# STAFF REPORT

**Agenda Title:** For Possible Action: To consider a request from Silver Oak Development, L.P. (property owner: Silver Oak Development Co., Ltd.) to modify the Silver Oak Planned Unit Development to add 31 single family residential lots in a new phase to be known as Silver Oak Phase 21, on property zoned Single Family 12,000 – Planned Unit Development (SF12-P), located at 2951 Oak Ridge Drive, APN 007-462-12. (TPUD-16-012)

**STAFF REPORT FOR THE PLANNING COMMISSION MEETING OF MARCH 30, 2016**

**DATE:** March 11, 2016  
**TO:** Susan Pansky and Kathe Green – Planning  
**FROM:** Rory Hogen – Engineering  
**RE:** TPUD 16-012 Tentative PUD Map for Silver Oak Ph 21 PUD  
Engineering Text for Planning Commission Staff Report

**TENTATIVE SITE PLAN**  
**APN: 007-462-12**  
**SILVER OAK PHASE 21 - OAK RIDGE DRIVE**  
**CARSON CITY NV**

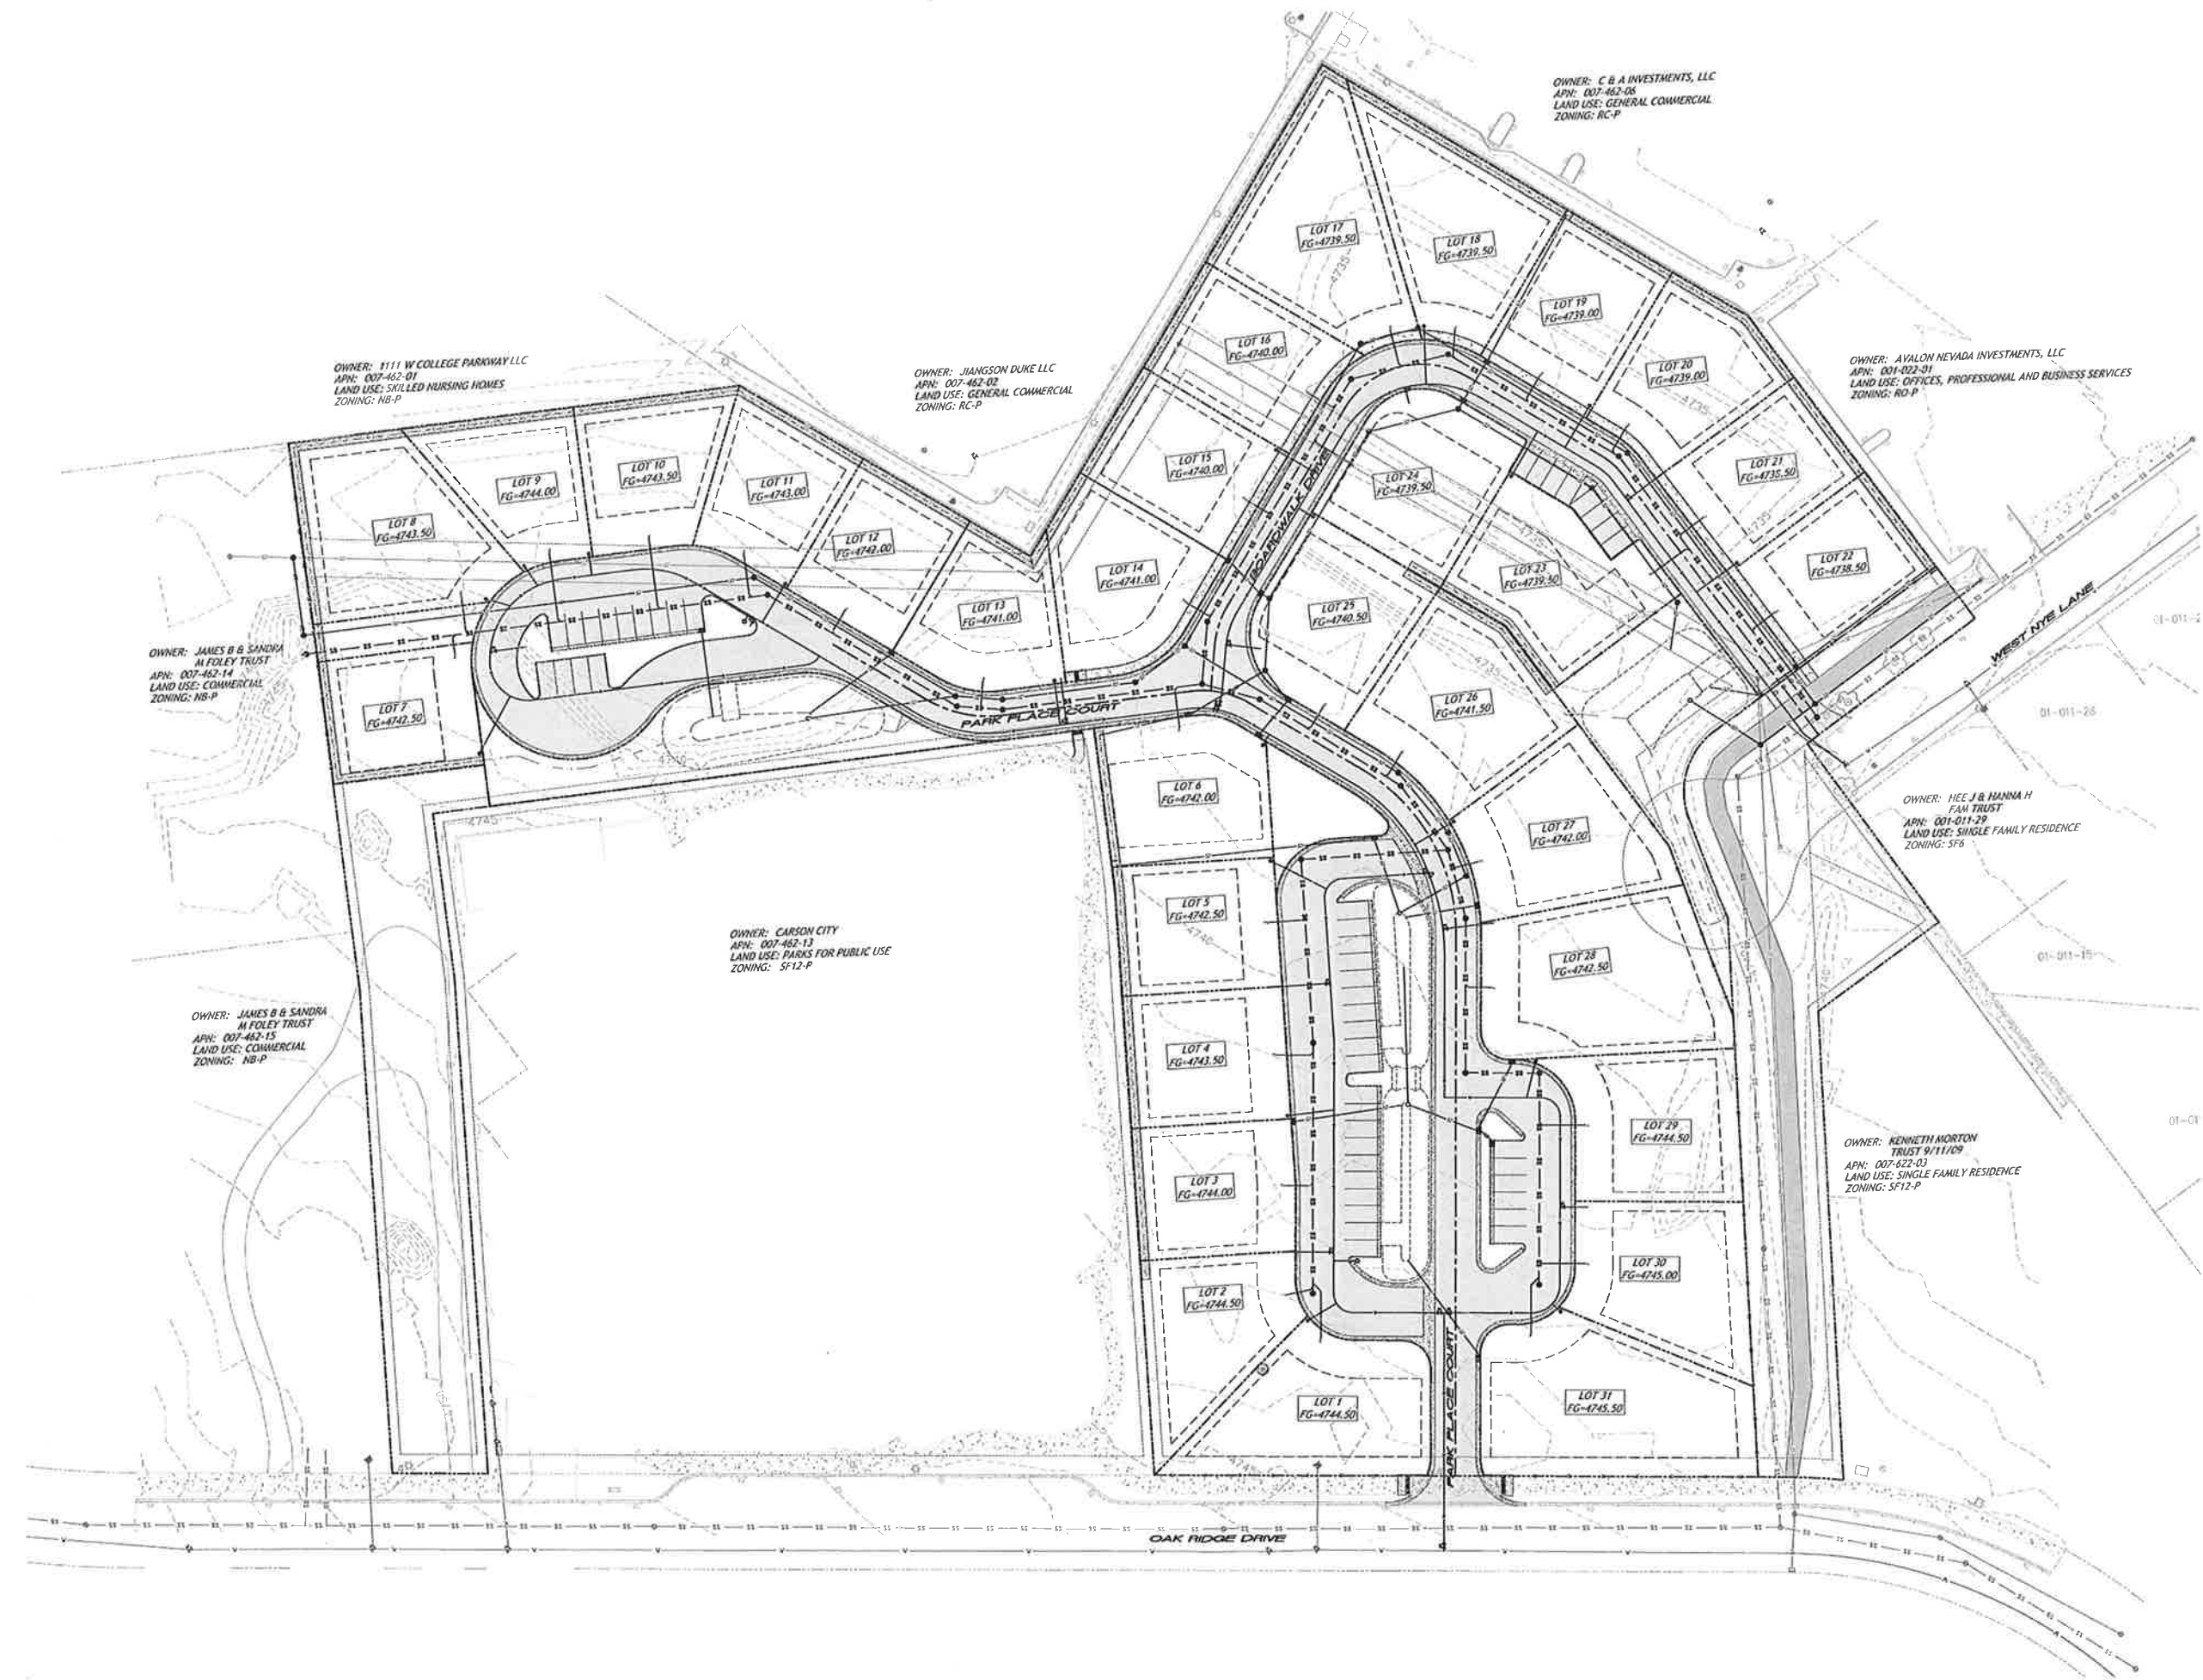
There are continued concerns with traffic and speeding in this area and specifically right in the area where this proposed development will access Oak Ridge Drive. The design of the neighborhood has limited connectivity, causing Oak Ridge Drive to be used as a through route, not just to access residences. The Public Works Department has received numerous complaints about this situation and recently conducted traffic counts which show that the speeding issue persists. The park is also very popular, and users of that park and residents in the homes recently constructed on the west side of Oak Ridge Drive are among those who have expressed concerns. Public Works implemented several measures last year in this area including a centerline, striping for the parking at the park, and concrete islands on the east side of the road. While those improvements were valuable and appreciated, concerns remain.

As it relates to this project, the additional traffic at this location is cause for greater concern. With the connection to Nye Lane on the east side being for emergency access only, that means all traffic will be focused to and from Oak Ridge Drive right in the area of concern. The appropriate action will be to install STOP signs on Oak Ridge Drive at the new three-way intersection created when this development is constructed. However, the design does not take into account where the new road will intersect with Oak ridge Drive and interact with the driveways for the homes on the west side of the street. As currently designed, the new street will not line-up with a driveway. If the development is constructed as currently designed, there will be negative consequences for motorists and the property owners on the west side of the road. When installing the STOP signs, the two homeowners would lose all street parking between their homes because that would be part of the three-way intersection. Additionally, the installation of the STOP signs will be awkward as best, as Public Works would be installing them and the associated striping around the existing driveways.

The solution is to modify the design of the planned development to line-up the new street with one of the existing driveways. I understand that the developer will view this change negatively, but if this change is not made, the City and the residents of this development and current residents will have to deal with additional negative traffic impacts indefinitely. The city would need to look into further modification of this road at city cost because the design did not appropriately address the concerns. There is already a difficult situation with safety concerns which is gotten worse with each development in this area. While this is not a "perfect" solution, I strongly believe we need to consider the traffic issues in this area very carefully.

12. The new road which will serve as the access and egress point for the development will be implemented to align with an existing driveway on the west side of Oak Ridge Drive. The developer will implement a three-way STOP condition at the intersection of the new road being constructed where it intersects Oak Ridge Drive. The developer will submit plans for signing and striping to Carson City Development Engineering for approval prior to implementation.
